The Oil and Natural Gas
Conservation Board

May 15, 1991

Re: Virden Roselea Unit No. 1
Reduced Spacing Project Approval

The Board has considered your application for reduced 8 ha spacing and conversion of two wells to water injection in a portion of Virden Roselea Unit No. 1. Attached are copies of Board Order No. SU 8 and Board Order No. PM 65 approving the application.

FIGURE 1

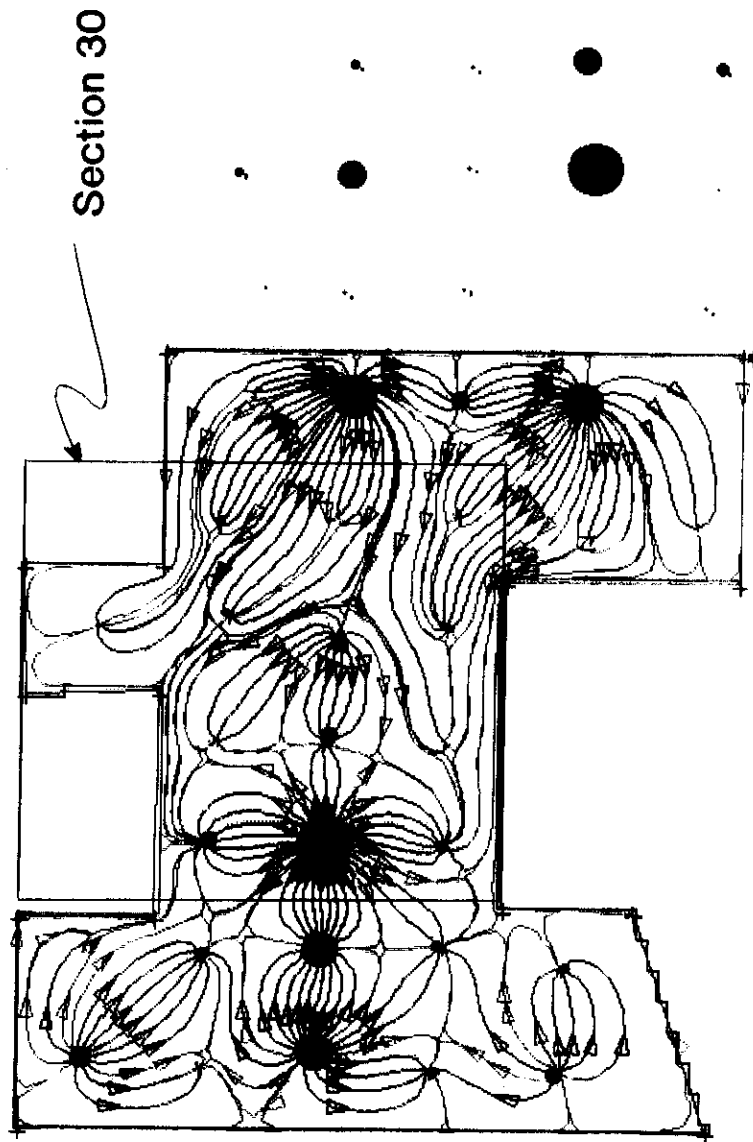
The incremental recovery in the Sandhill and Oolite members will result from improved sweep. Figures 1 and 2 show streamtube maps generated for the infill area. The area covered by the streamtube maps is outlined on the Unit Map in Figure 3. In Figure 1 the streamtubes were generated for the existing project. In Figure 2 the streamtubes were generated for the proposed infill project. Better sweep of the infill area is noted in Figure 2, especially in the eastern portion.

STRUCTURE ON TOP OF CHERTY
(FEET SUBSEA)

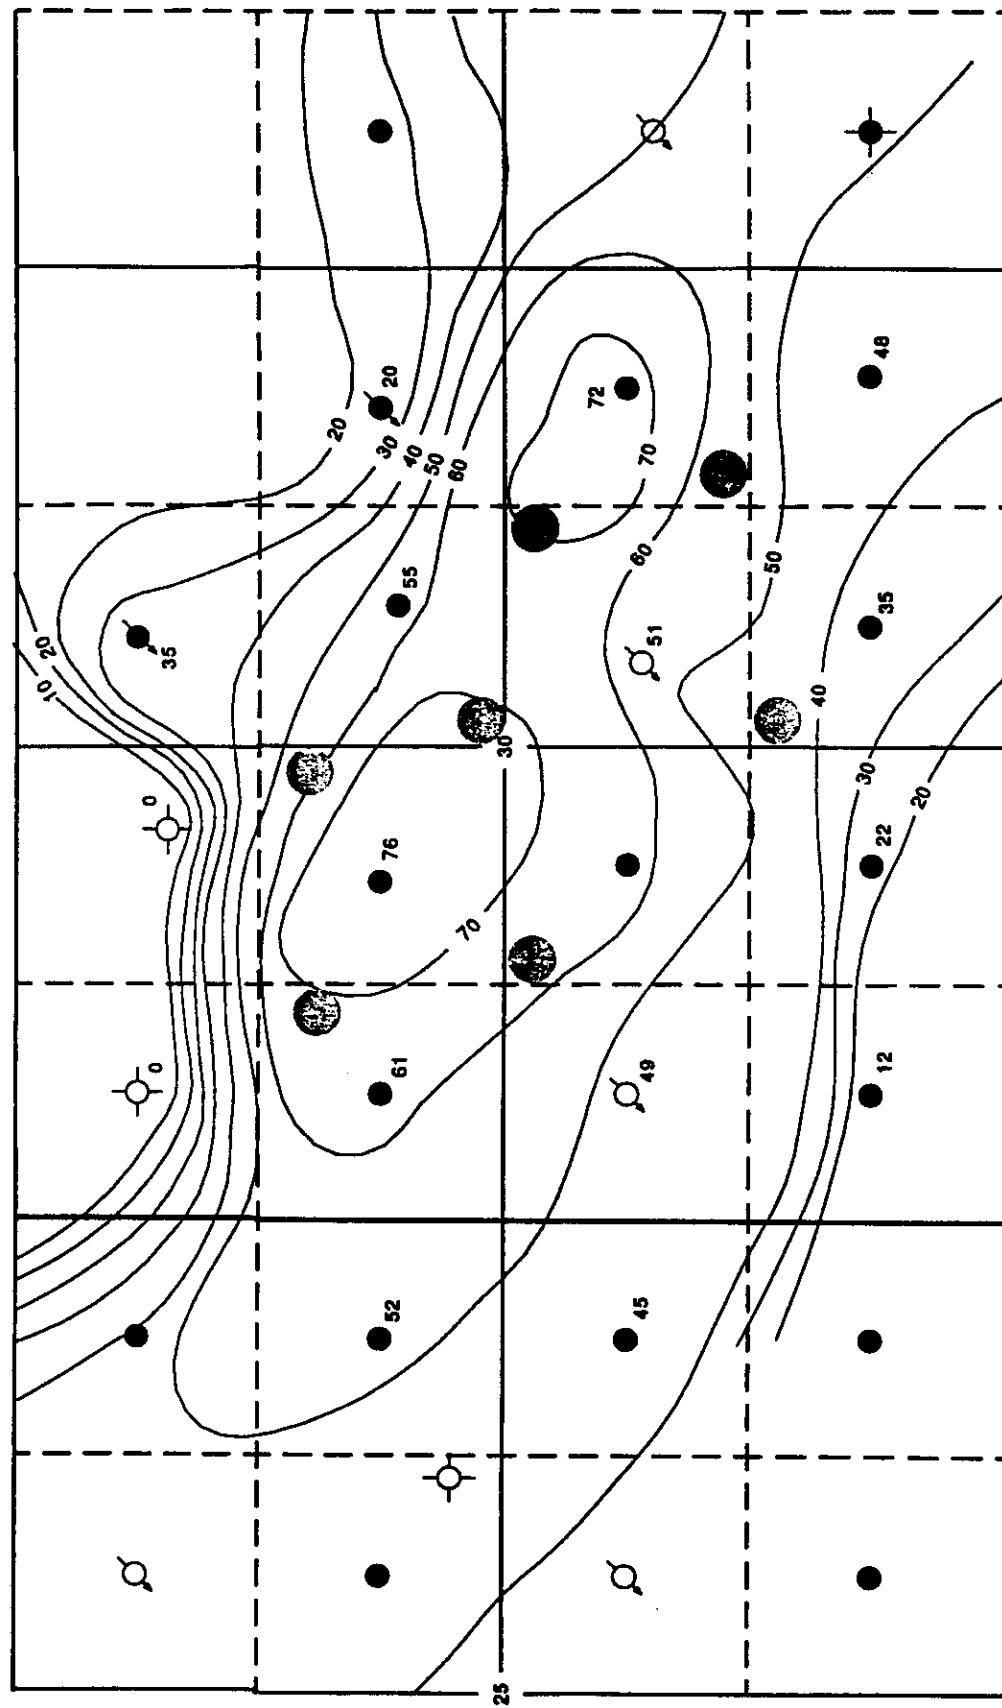
The project area overlies a NW-SE structural high centered on Lsd's 6, 7, 8, 9, 10, & 11 of Section 30. Figure 2 is a structure map on the top of the Cherty showing the extent of the structural high.

Structure has had a significant effect on waterflood performance in the project area. There is a direct correlation between productivity, WOR and structure (Figure 2). The wells at the apex of the structure furthest remove from the oil/water contact have the highest productivity and lowest WOR.

The 7 proposed infill locations are all located near the apex of the structural high in Section 30-10-25 (WPM) where the top of the Cherty is a minimum of 7.0 m above the estimated oil/water contact (Figure 2). The importance of structural position can be measured by the estimated 4 800 m³ recoverable reserves per metre of Cherty pay (based on 16 ha spacing) that may be trapped as an "attic loss" if wells are not drilled at the apex of the structure.

FIGURE 3

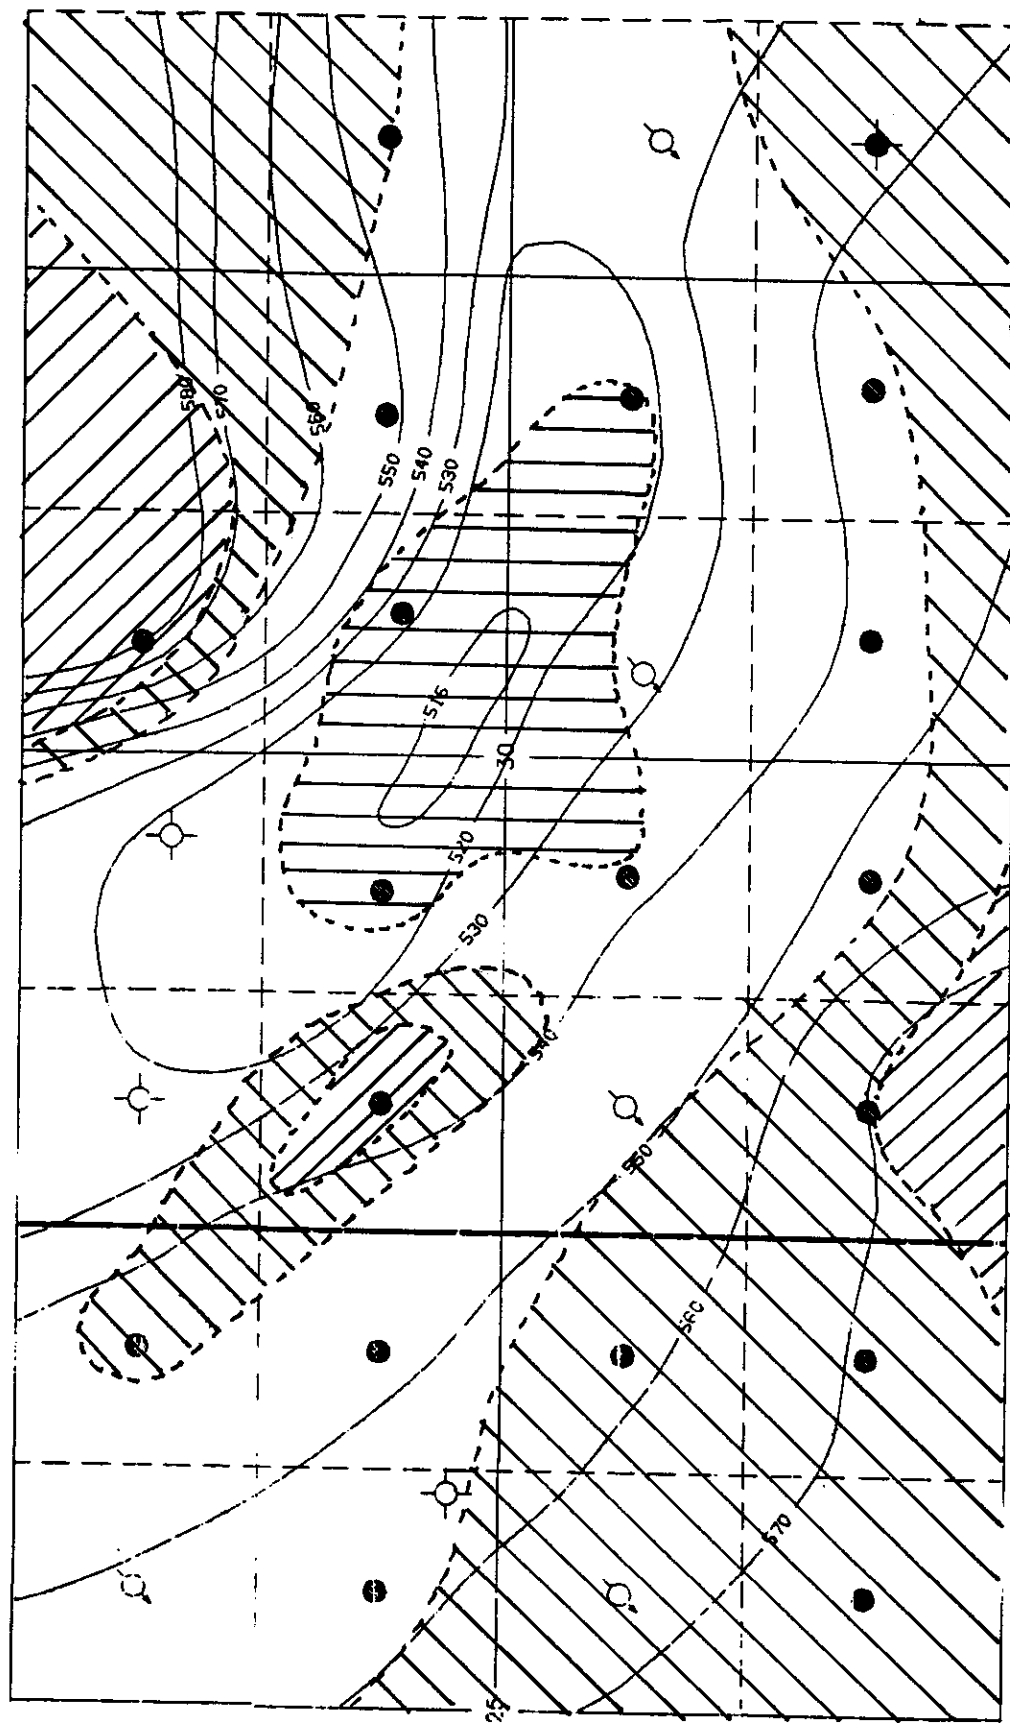
The Crinoidal, Sandhill and Oolites are continuous over the structural high, though in wells at the apex of the structure some of these zones have been dolomitized and are tight. The Cherty pay above the estimated oil/water contact (-171.6 m subsea) thickens from zero on the flanks of the structure to 13.7 m at the apex of the structure. Figure 3 is a net pay map showing the total net pay thickness for all zones.

REDUCED SPACING PROJECT PRODUCTION HISTORY

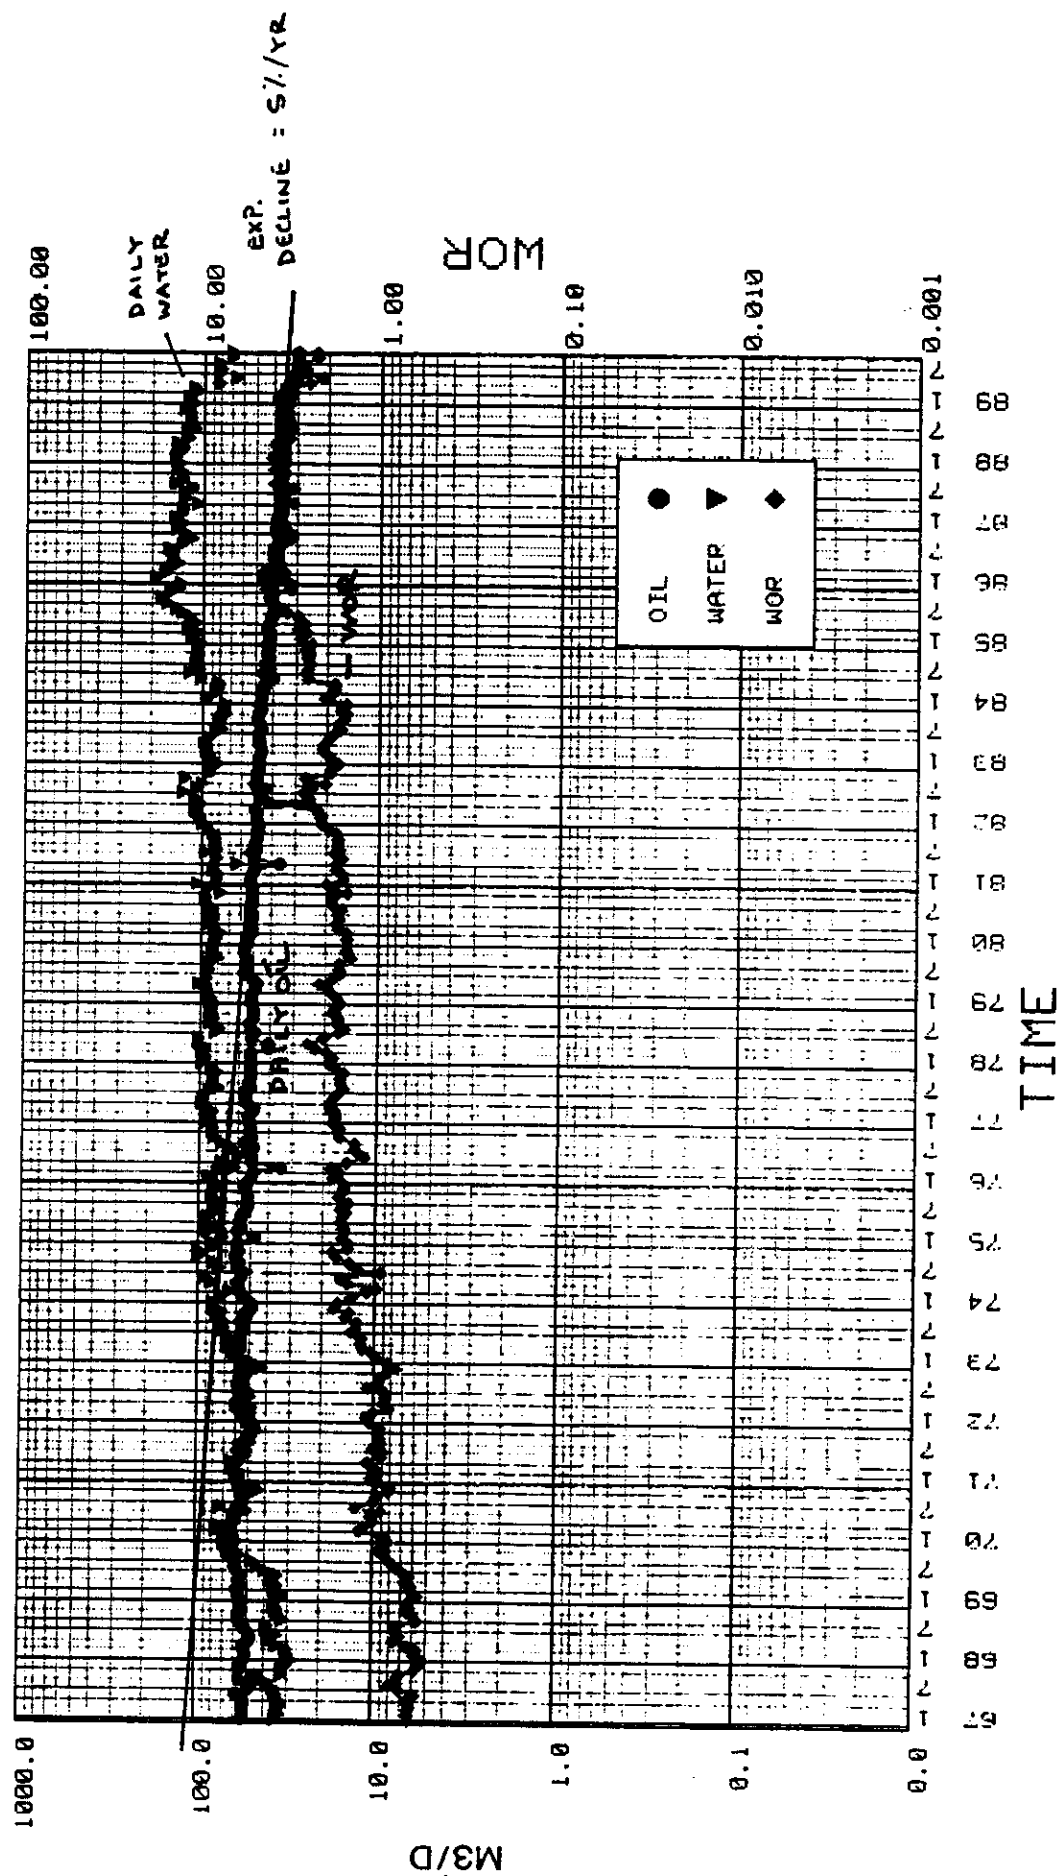
The current recovery in VRU No. 1 is $2\,208 \times 10^3 \text{ m}^3$ or 27.8% OOIP. The current recovery in the project area is $585 \times 10^3 \text{ m}^3$ or 21.7% OOIP. The predicted ultimate recovery for VRU No. 1 is 34.8% OOIP, compared to an ultimate recovery of between 27.8% (Petroleum Branch) to 31% (Chevron) for the project area. The difference in recovery estimates is based on different decline curve interpretations. Chevron has estimated an exponential decline rate of 2.6%/year for the project area, compared to a 5.0%/year decline estimated by the Petroleum Branch. Figure 5 is a plot of the project area production history.

NVSU #1 INFILL PROJECT

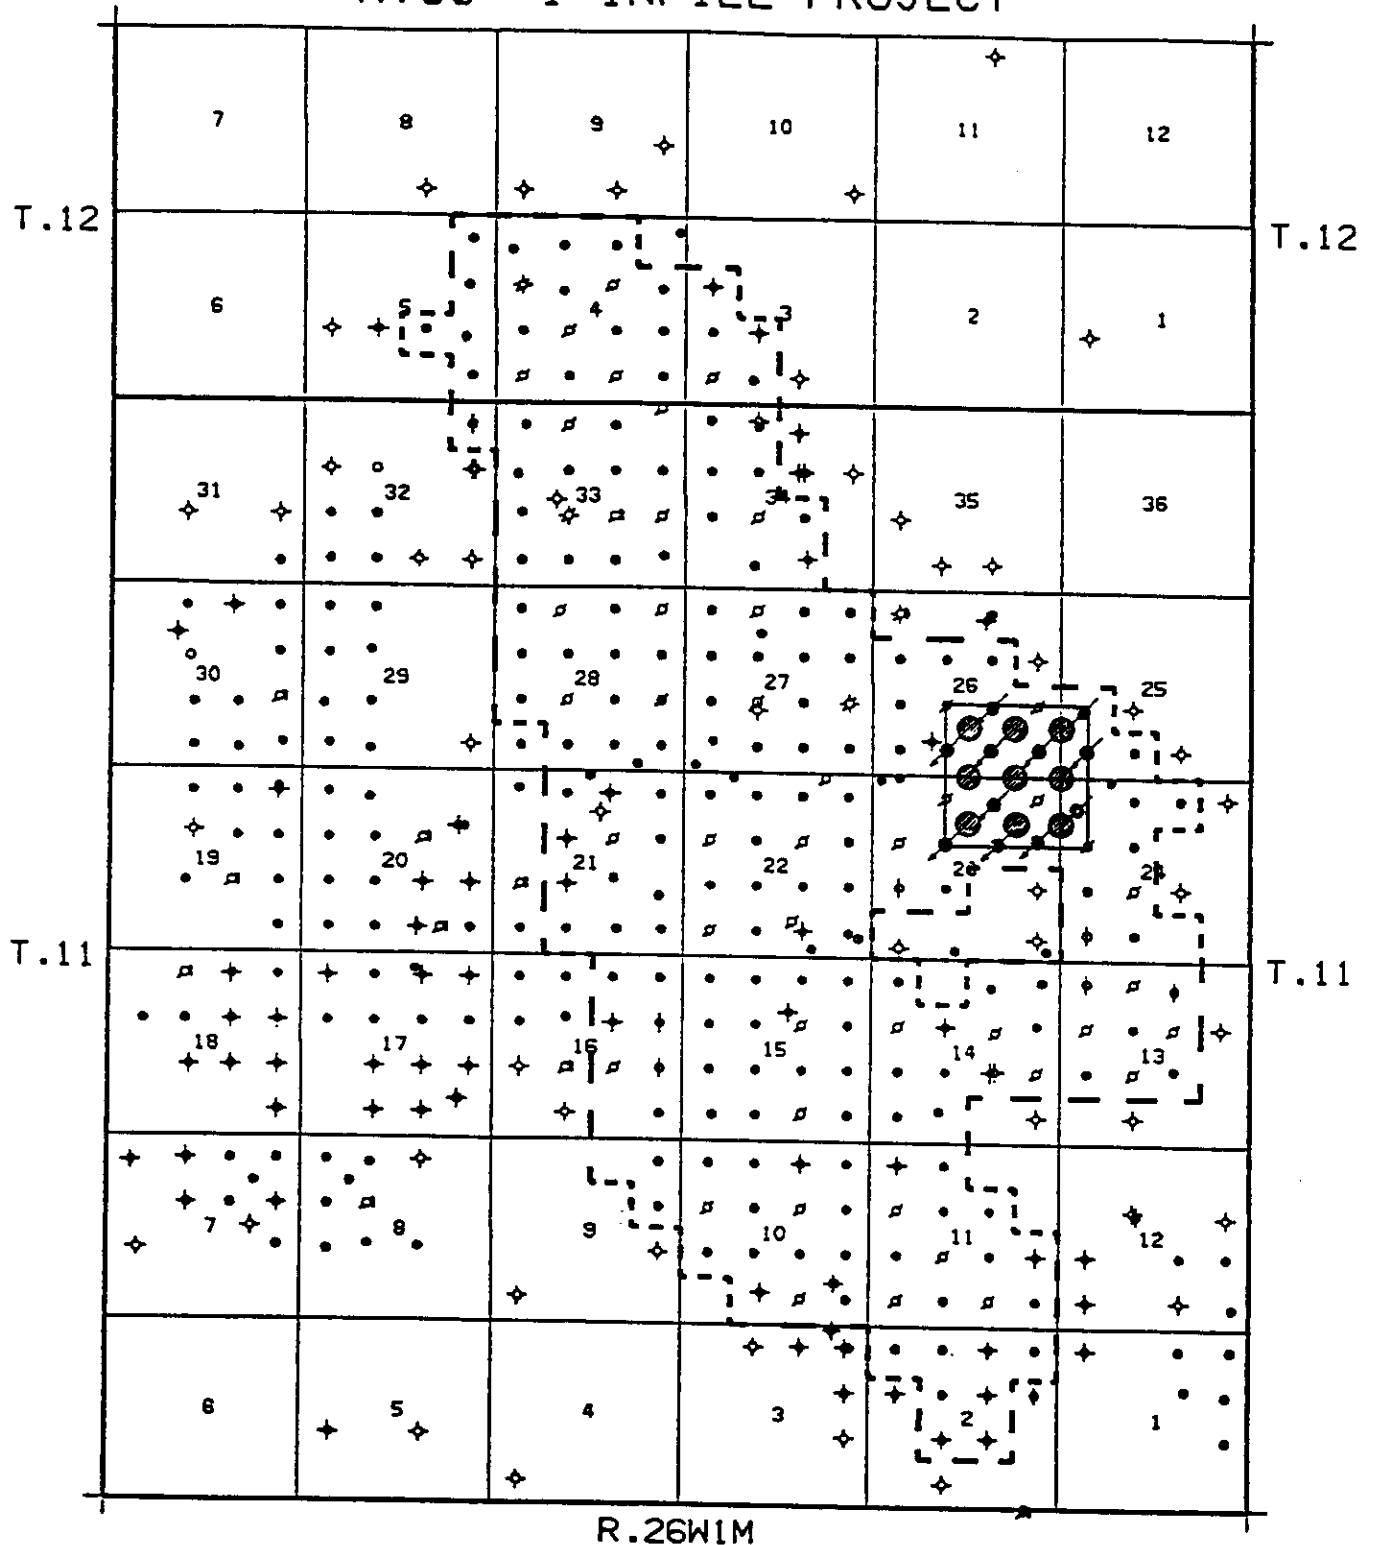
The NVSU No. 1 reduced spacing project included the drilling of 9 infill wells and the conversion of 11 producers to water injection to develop a number of 8 ha 5-spot injection patterns (Figure 6). The predicted incremental recovery, based on improved zonal continuity and improved areal sweep efficiency was 100,000 m³ or 7.6% OOIP.
